STATE OF DELAWARE
DEPARTMENT OF TRANSPORTATION
 800 BAY ROAD
 P.O. Box 778
 DOVER, DELAWARE 19903

MEMORANDUM

SUBJECT: Interim Guidance; Part 2, Signs

This Interim Guidance to the Delaware Manual on Uniform Traffic Control Devices (MUTCD) is related to the use of the Electric Vehicle (EV) Charging Station symbol general service sign.

Figure 1: Alternate Electronic Vehicle Charging Station Symbol Sign

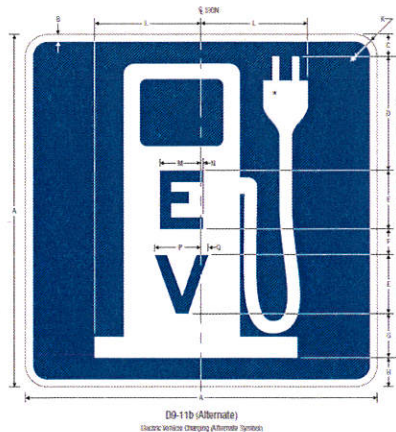
23 (DE Revision) In accordance with the Interim Approval received from the FHWA, the alternative Electric Vehicle (EV) Charging symbol sign (Figure 1) may be used in lieu of the approved EV Charging symbol sign (D9-11b).

24 (DE Revision) If used, no more than two EV charging station signs per facility (one sign in each direction on the primary road accessed by the facility) should be installed.

25 (DE Revision) The cost to install EV charging station signs shall be the responsibility of the entity requesting the signs.

26 (DE Revision) EV charging station signs shall not be located where they will interfere with more critical regulatory, warning, or guide signs.
